Our ref: 10668  
Council ref: A006350223

**RE: CHANGE APPLICATION (MINOR CHANGE)  
SECTION 81 OF THE *PLANNING ACT 2016*  
6 WELLINGTON RD EAST BRISBANE, 14, 16, 18 WELLINGTON RD, WOOLLOONGABBA  
AND 25 NILE ST WOLLOONGABBA QUEENSLAND 4102 (LOT 1 ON RP123545, LOT 2 ON  
RP123545, LOT 3 ON RP122636, LOT 1 ON RP42898 AND LOT 1 ON RP122636)**

On behalf of 25 Nile Pty Ltd (the Applicant), this minor change seeks to amend the previous approval issued by BCC on 27 November 2024 (Application Ref: A006350223) as follows:

**Figure 1: Proposed Stage 1 Staging Line and Separation Wall**

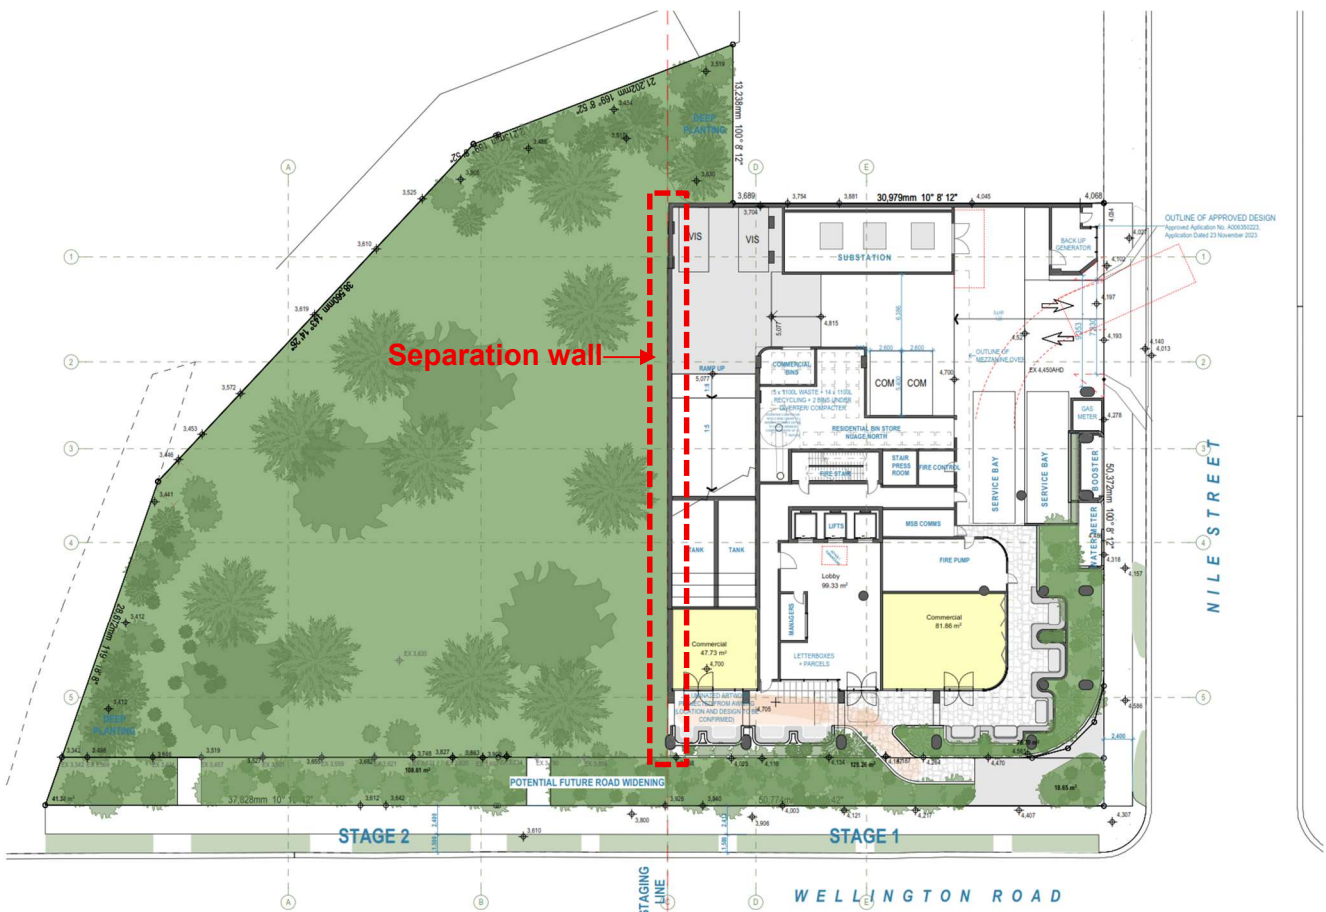
Stage 1 has been designed to ensure seamless integration with Stage 2 once both towers are completed. The staging arrangement incorporates a separation wall along the staging line (as shown in **Figure 1** and highlighted in red), enabling Stage 1 to operate independently. Upon

**Figure 2: Proposed Circulation layout upon commencement of Stage 2**

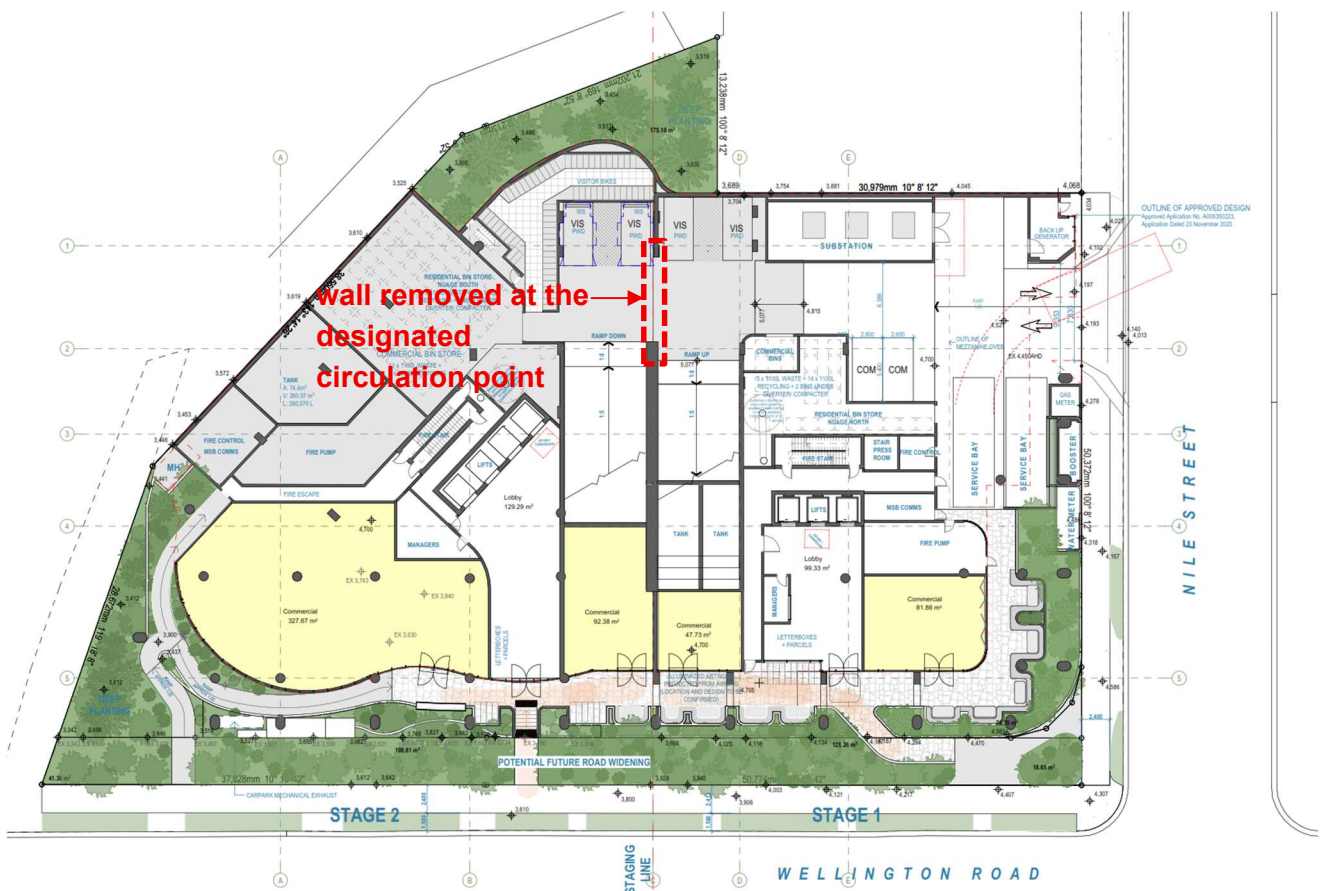
commencement of Stage 2, this wall will be partially removed, connecting the building across both Stage 1 and Stage 2. Vehicular access constructed as part of Stage 1 will service the mezzanine and podium levels, while Stage 2 will provide access to the basement levels. This approach ensures coordinated vehicular circulation across both stages, while maintaining full functionality during the interim operation of Stage 1 (refer to **Figure 2**).

On the top of podium, upon construction of Stage 2, the top of podium will be joined with Stage 1 to create the large central communal park (approximately half of which will be provided in Stage 1).

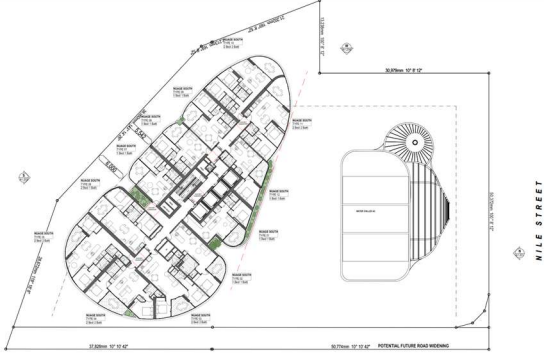
Aspect	Proposed Development	Existing Approval																																				
<b>Podium Level 6</b>																																						
<p><b>Layout</b></p>	 <p>The development comprises two high-density residential towers delivered in stages:</p> <ul style="list-style-type: none"> <li>▪ Stage 1- Nuage North; and</li> <li>▪ Stage 2- Nuage South;</li> </ul> <p>With the following dwelling mix as shown below.</p>	 <p>The development comprises two high-density residential towers – Nuage North and Nuage South, with the following dwelling mix as shown below.</p>																																				
<p><b>Stage 1</b></p>	<p>Includes <b>08</b> dwelling units, including a mix of two and three-bedroom apartments across 08 typologies.</p> <table border="1" data-bbox="300 1189 855 1832"> <tr><td>Type 01</td><td>2Bed/2Bath/MPR</td></tr> <tr><td>Type 02</td><td>3Bed/2Bath/MPR</td></tr> <tr><td>Type 03</td><td>2Bed/2Bath</td></tr> <tr><td>Type 04</td><td>2Bed/2Bath</td></tr> <tr><td>Type 05</td><td>3Bed/2Bath</td></tr> <tr><td>Type 06</td><td>2Bed/2Bath/ MPR</td></tr> <tr><td>Type 07</td><td>2Bed/1Bath</td></tr> <tr><td>Type 08</td><td>2Bed/2Bath</td></tr> </table>	Type 01	2Bed/2Bath/MPR	Type 02	3Bed/2Bath/MPR	Type 03	2Bed/2Bath	Type 04	2Bed/2Bath	Type 05	3Bed/2Bath	Type 06	2Bed/2Bath/ MPR	Type 07	2Bed/1Bath	Type 08	2Bed/2Bath	<p>Includes 10 dwelling units, comprising a mix of one and two-bedroom apartments across 10 typologies.</p> <table border="1" data-bbox="887 1189 1442 1630"> <tr><td>Type 01</td><td>1Bed/1Bath</td></tr> <tr><td>Type 02</td><td>2Bed/ 2Bath</td></tr> <tr><td>Type 03</td><td>1Bed/1Bath</td></tr> <tr><td>Type 04</td><td>2Bed/2Bath</td></tr> <tr><td>Type 05</td><td>2Bed/2Bath</td></tr> <tr><td>Type 06</td><td>2Bed/ 2Bath</td></tr> <tr><td>Type 07</td><td>2Bed/2Bath</td></tr> <tr><td>Type 08</td><td>2Bed/2Bath</td></tr> <tr><td>Type 09</td><td>1Bed/1Bath</td></tr> <tr><td>Type 10</td><td>2Bed/2Bath</td></tr> </table>	Type 01	1Bed/1Bath	Type 02	2Bed/ 2Bath	Type 03	1Bed/1Bath	Type 04	2Bed/2Bath	Type 05	2Bed/2Bath	Type 06	2Bed/ 2Bath	Type 07	2Bed/2Bath	Type 08	2Bed/2Bath	Type 09	1Bed/1Bath	Type 10	2Bed/2Bath

Type 10	2Bed/2Bath																																					
<p><b>Stage 2</b></p>	<p>Consistent with the approved design and dwelling configuration.</p>	<p>12 dwelling units, comprising a mix of one- and two-bedroom apartments across 12 typologies.</p>

Type 10	2Bed/2Bath	74.32	13.59	Type 10	2Bed/2Bath
	Type 11	2Bed/2Bath	71.94	15.86	Type 11	2Bed/2Bath
	Type 12	1Bed/1Bath	51.12	10.00	Type 12	1Bed/1Bath
<b>Proposed Level 27</b>

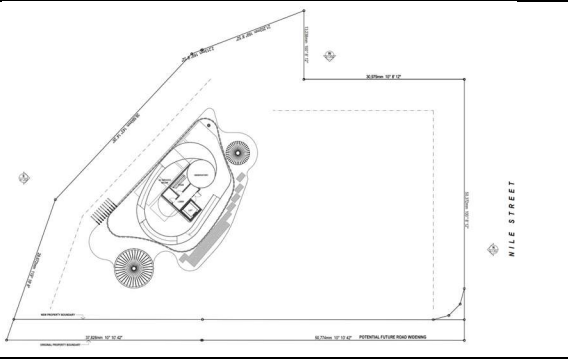
Aspect	Proposed Development	Existing Approval
<b>Layout</b>		
<b>Stage 1</b>	<ul style="list-style-type: none"> <li>▪ <b>Service Mezzanine (Plant)</b>– 348.03 m<sup>2</sup></li> <li>▪ Pool (depth)</li> <li>▪ <b>Communal Open Space</b></li> <li>▪ Fire Pit</li> <li>▪ Seating nooks</li> <li>▪ Day beds</li> <li>▪ Yoga Lawn</li> </ul> <p>Inclusion of a new services mezzanine floor, which was not part of the approved package.</p>	<ul style="list-style-type: none"> <li>▪ <b>Services Mezzanine include:</b></li> <li>▪ Tank – 143.99 m<sup>2</sup></li> <li>▪ 02 Press rooms</li> <li>▪ 02 Lift shafts</li> <li>▪ Staircase</li> <li>▪ <b>Terrace Communal Recreation</b></li> <li>▪ BBQ (Kitchen/Dining)</li> <li>▪ 01 Dining Booth</li> <li>▪ 04 Cabanas</li> <li>▪ Infinity Pool</li> <li>▪ Communal Recreation</li> <li>▪ Gym</li> </ul>
<b>Stage 2</b>	No change	Same as level below.
<b>Proposed Level 28</b>		
<b>Layout</b>

**Figure 3** below illustrates the south elevation, with the red outline denoting the previously approved building mass and bulk. For further details, refer to **Attachments A & B**.

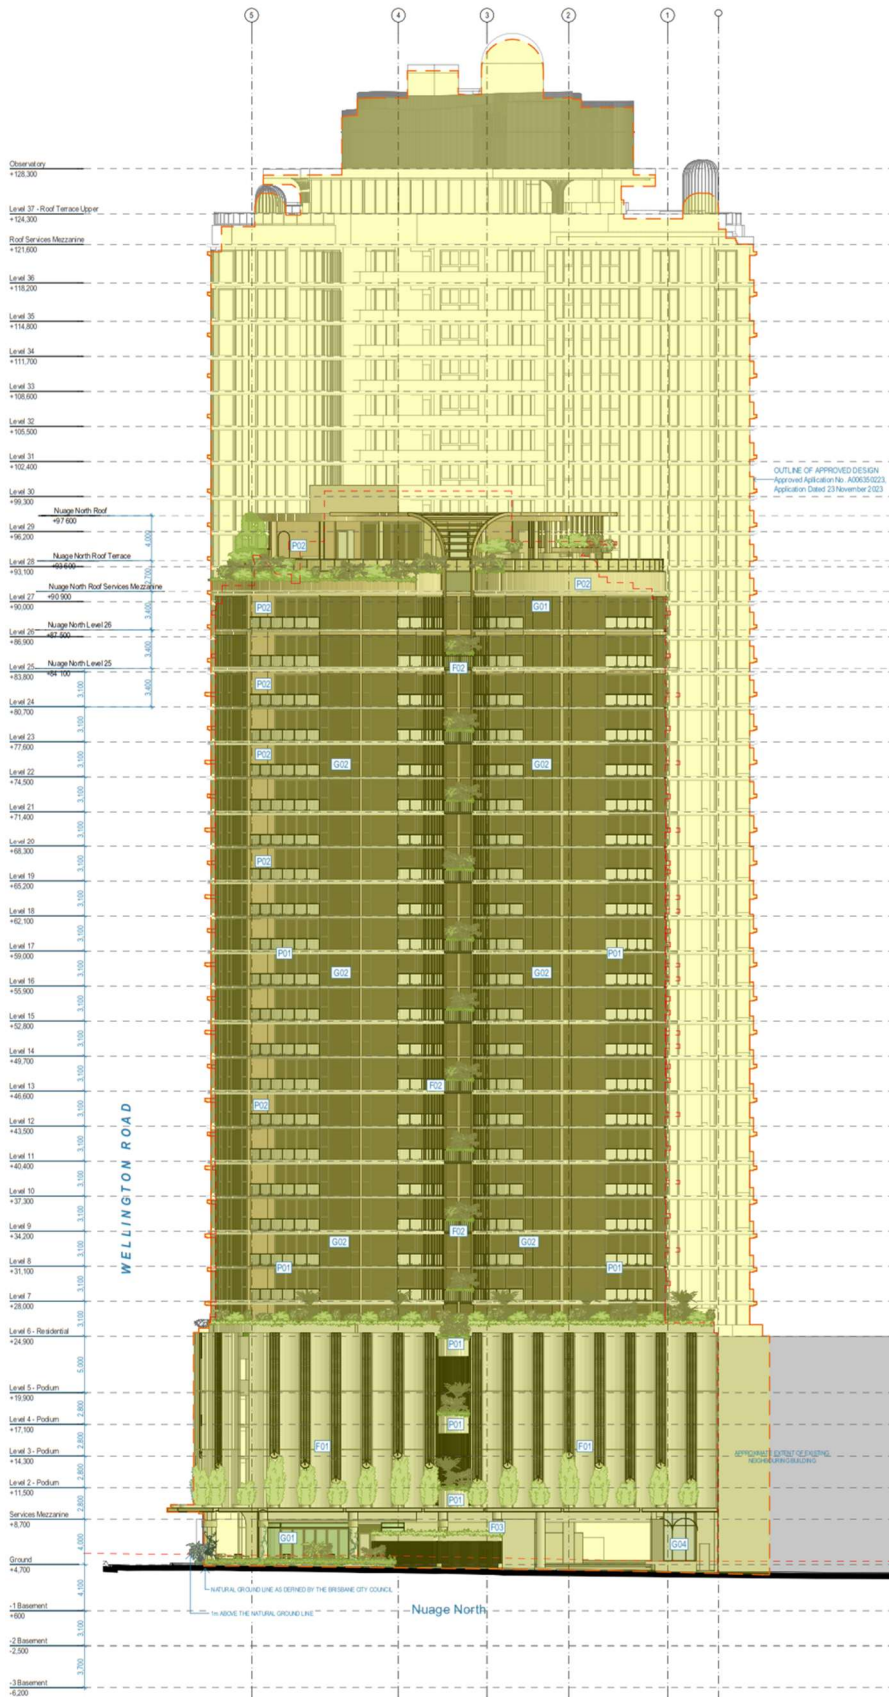
Only minor amendments have been made compared to the current approval, involving modifications to apartment layouts and balcony sizes as outlined in the table above. An additional services level (Level 27) has been introduced, utilised as the mechanical

plant/mezzanine servicing area. Although a new services level is proposed, the overall number of storeys remains unchanged.

The overall height and podium height has not changed (Nuage North top of podium remains RL24.9m and tower remains RL100.3m). Floor to floor heights within the building have been marginally modified, as noted on the proposed elevations.
